Bulletin No.: 15168  
Date: March 2015

# Recall Bulletin

**SUBJECT:** Loss of Electric Power Steering Assist

**MODELS:** 2015 Buick Encore  
2015 Chevrolet Trax

Location of steering column lot number

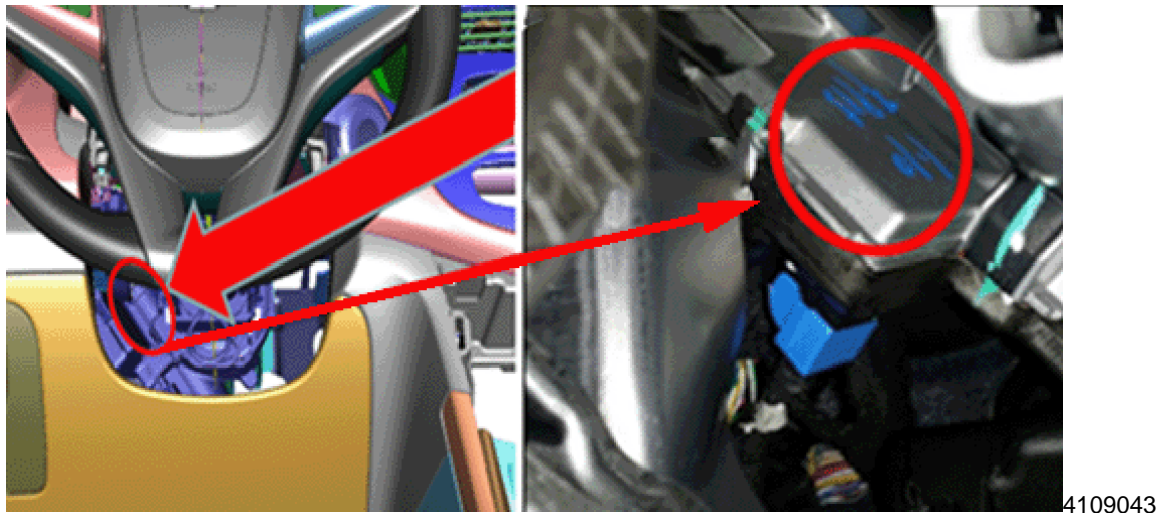
8. Check the housing LOT number.

**NOTE:** If the LOT number is illegible, or not readable, replace steering column.

9. A part with a LOT number (1) above 1200 (**including 1200, and up to and including 1600**) is **not OK** and must be replaced with a new steering column.
10. **If the LOT number is 1199 or less, then the part is OK** and the steering column does not need to be replaced. Do not go to the next step. Re-assemble parts in reverse order.
11. If the steering column has failed inspection, it will be necessary to replace the column. Refer to *Steering Column Replacement* in SI.
